## **ITEM FOR ENVIRONMENTAL COMMISSION AGENDA**

**NAME & NUMBER OF PROJECT:** Brodie Oaks Redevelopment PUD C814-2021-0099

**REQUEST:** PUD zoning for the property

RE: Brodie Oaks PUD needs changes to meet required “superior” standards, to comply with Austin’s Imagine Austin Comprehensive Plan, and to meet Water Forward and Climate Equity Plan goals

# Exhibit G: Grading Plan

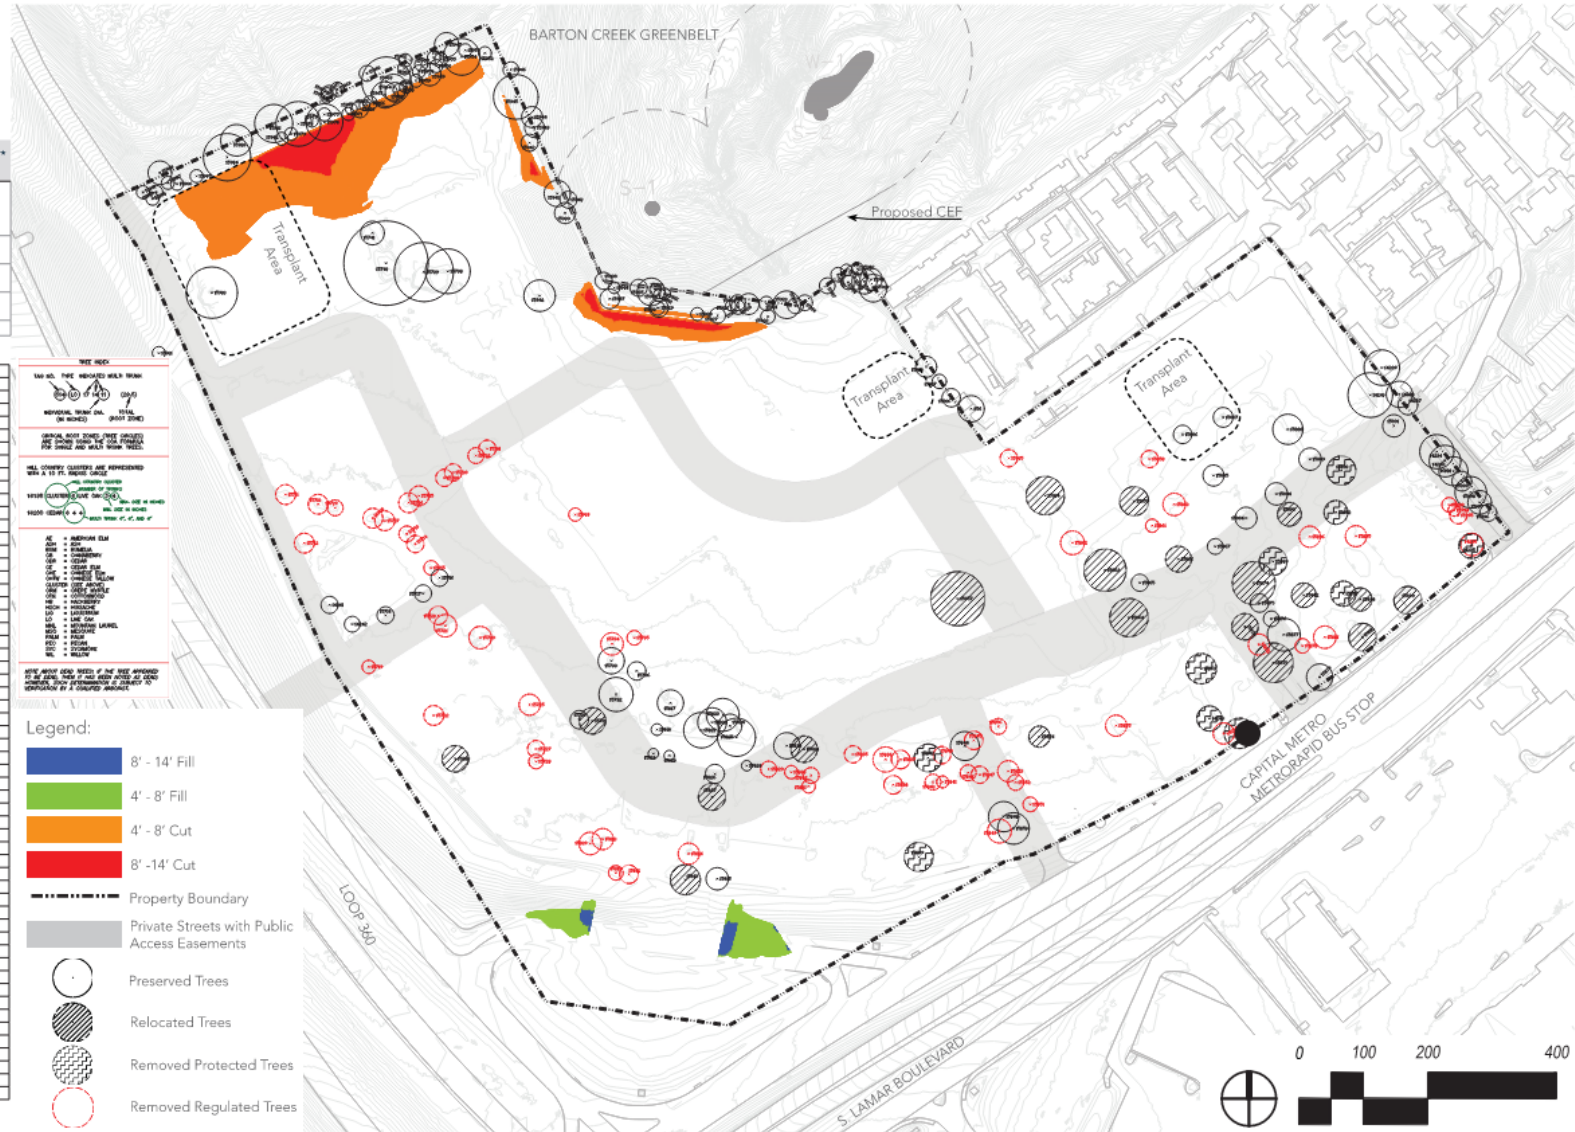
- **25-8-341 (Cut Requirements)** shall be modified to allow cut not to exceed a maximum of fourteen (14) feet as indicated on Exhibit G.
- **25-8-342 (Fill Requirements)** shall be modified to allow fill not to exceed a maximum of fourteen (14) feet as indicated on Exhibit G.
- **25-8-281 (Critical Environmental Features)** shall be modified to allow encroachment into CEFs as indicated on Exhibit F.
- **SOS Ordinance Section A of 25-8-514 (Pollution Prevention Required)** shall be modified to allow a maximum impervious cover for the site of 56% net site area.

# Exhibit F: Environment

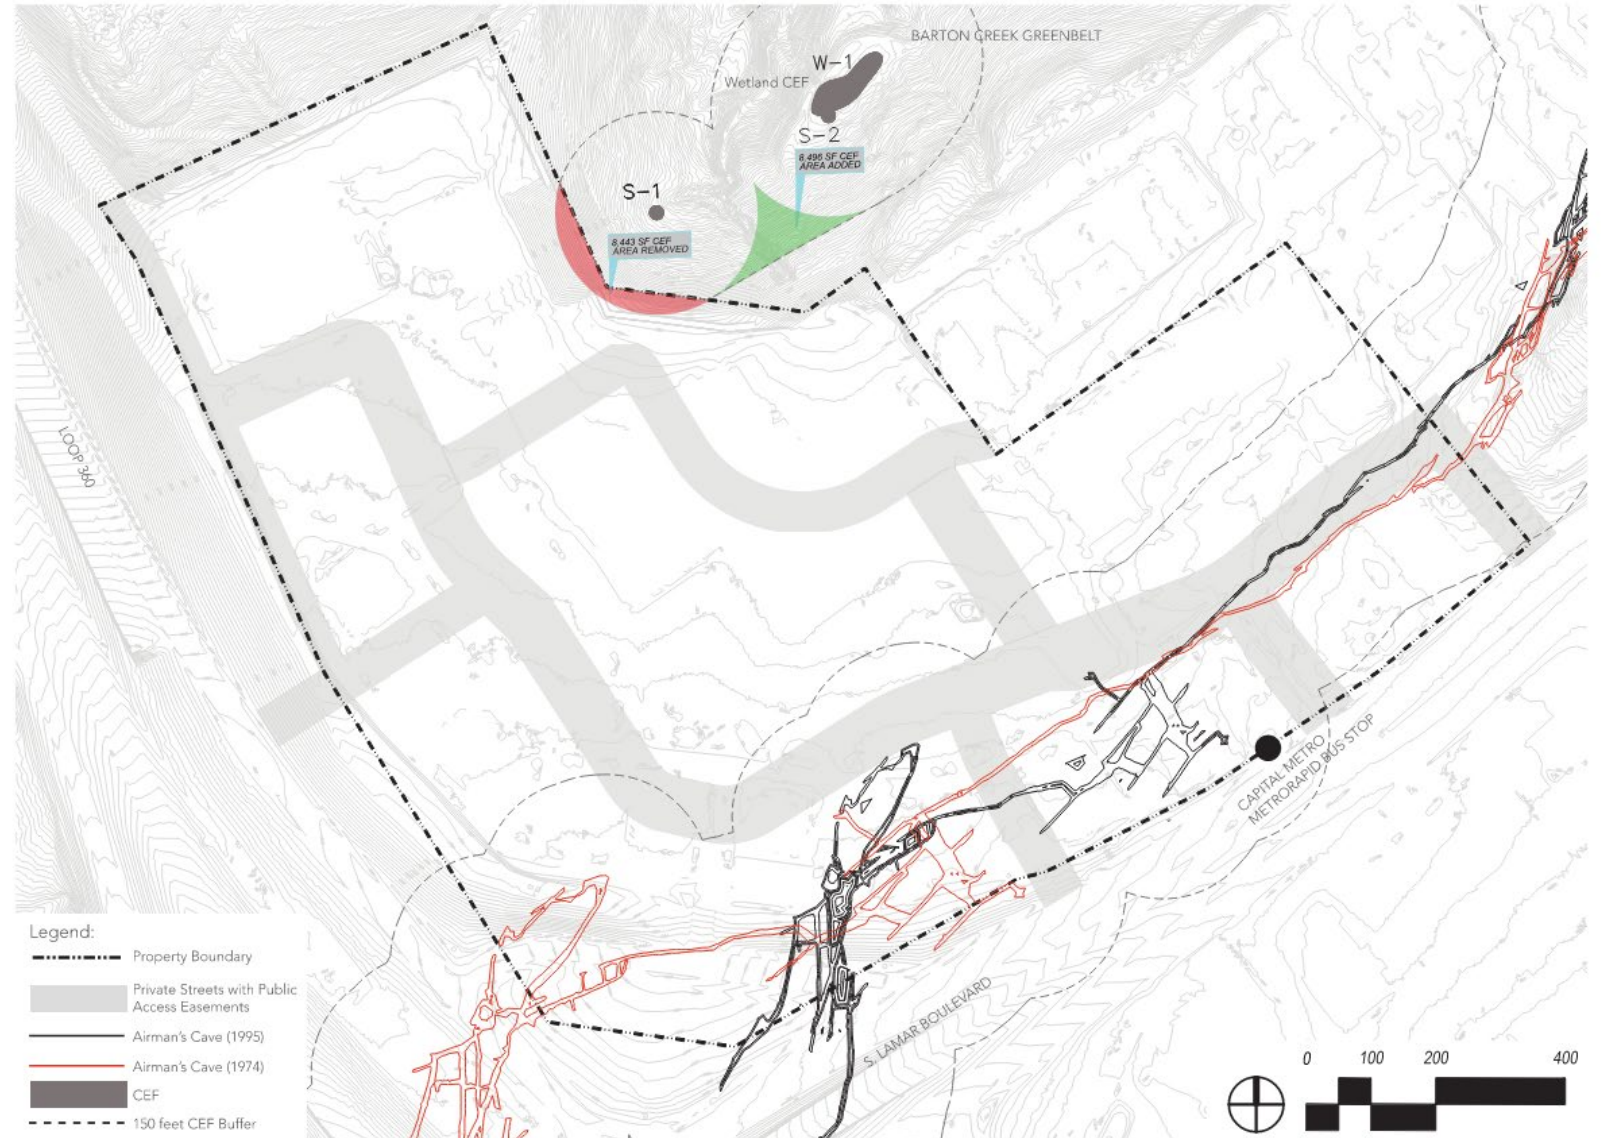
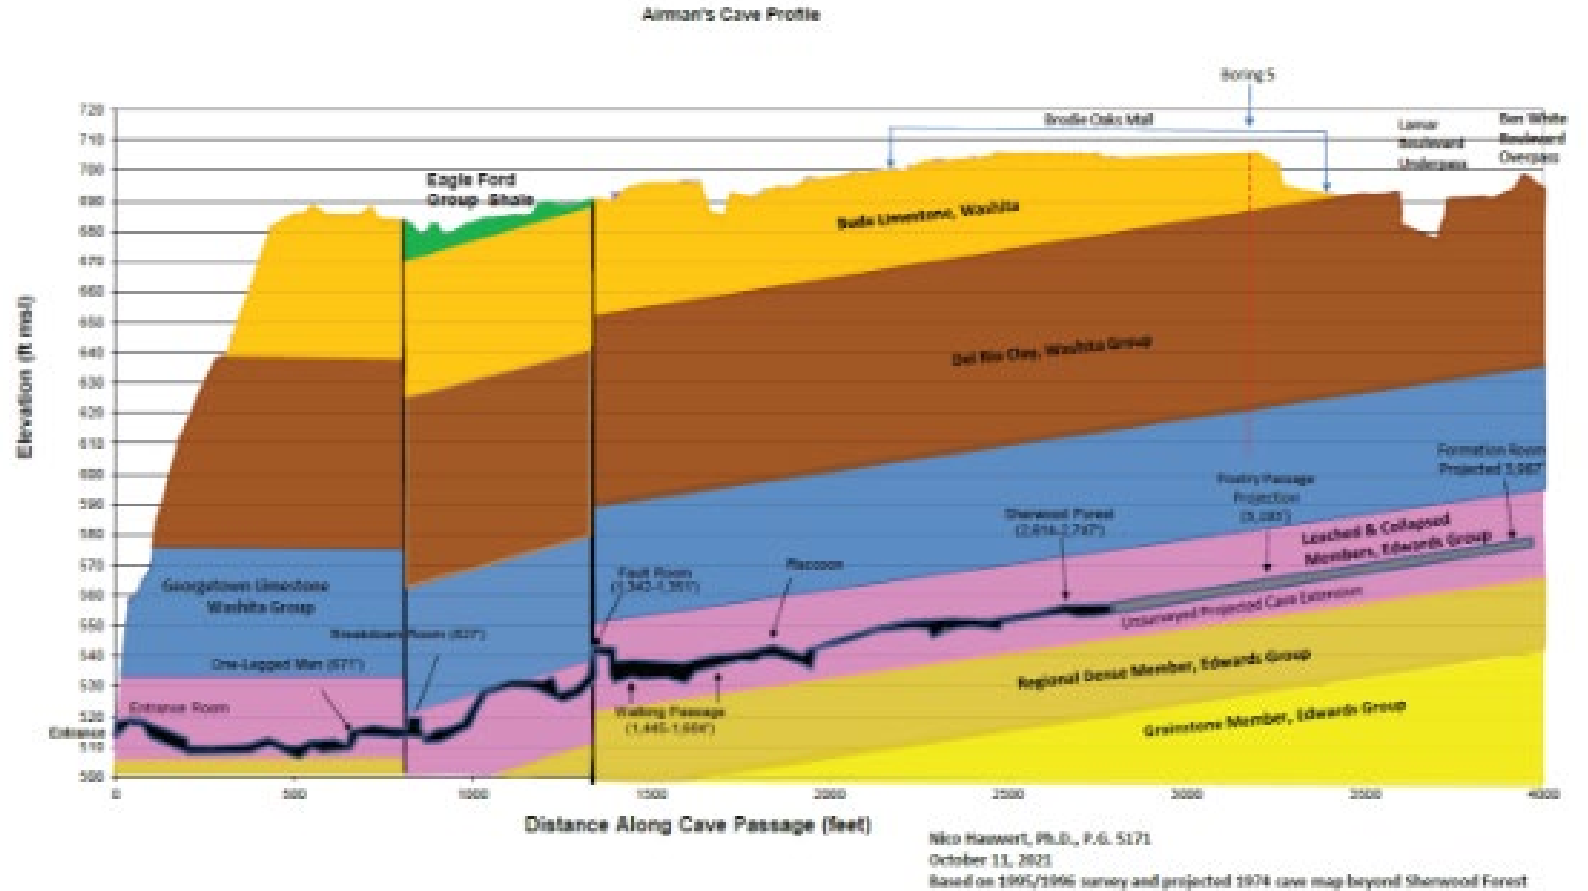
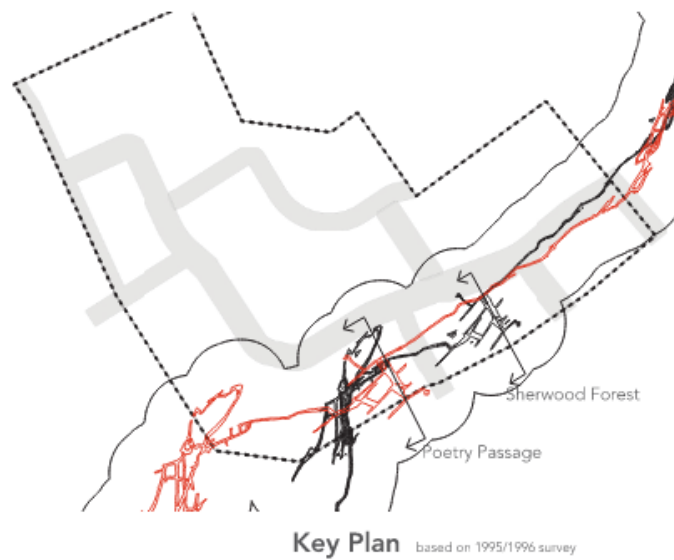
1. Modify CEF setback for S-1/S-2
2. Impact to Airman's Cave CEF setback is limited of up to 80' with conditions
3. Protective fencing for CEFs

## Exhibit F: Water Quality

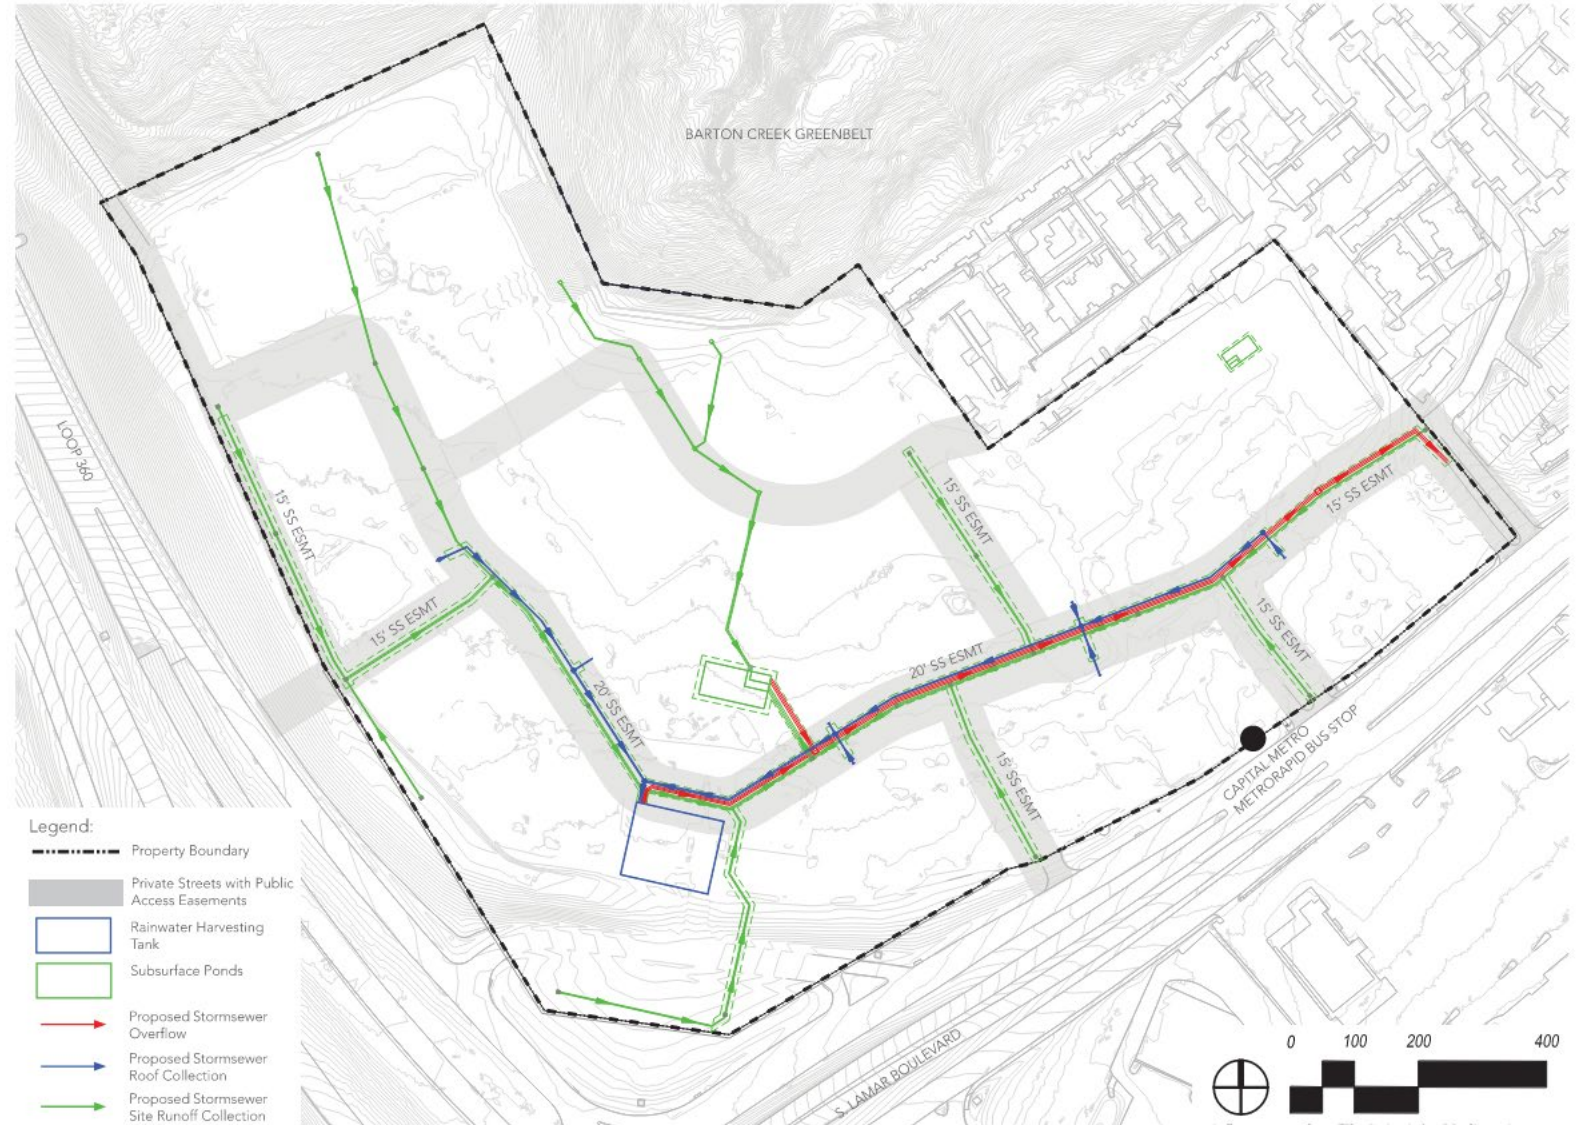
1. Brodie PUD will comply with SOS with subgrade ponds for retention/reirrigation system and rainwater harvesting with beneficial reuse
2. Infiltration testing
3. Trenching > 5' will be inspected by geologist

## Exhibit F: Water Quality

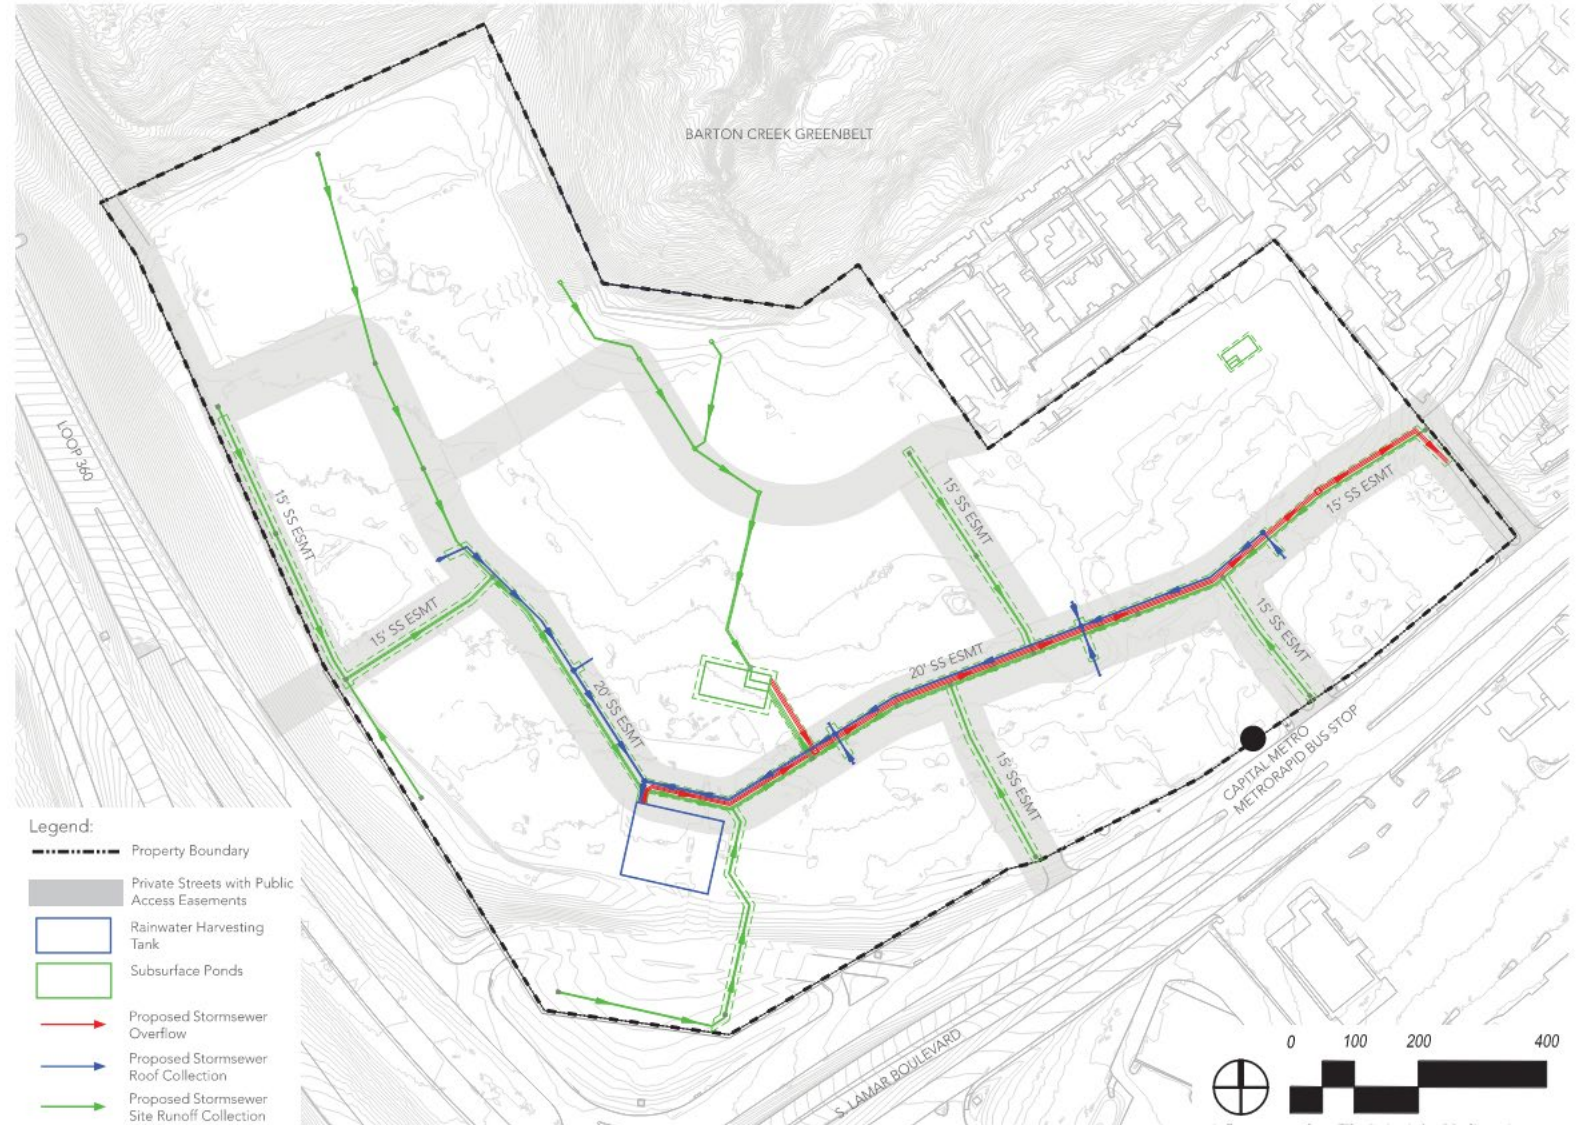
1. Brodie PUD will comply with SOS with subgrade ponds for retention/reirrigation system and rainwater harvesting with beneficial reuse
2. Infiltration testing
3. Trenching > 5' will be inspected by geologist
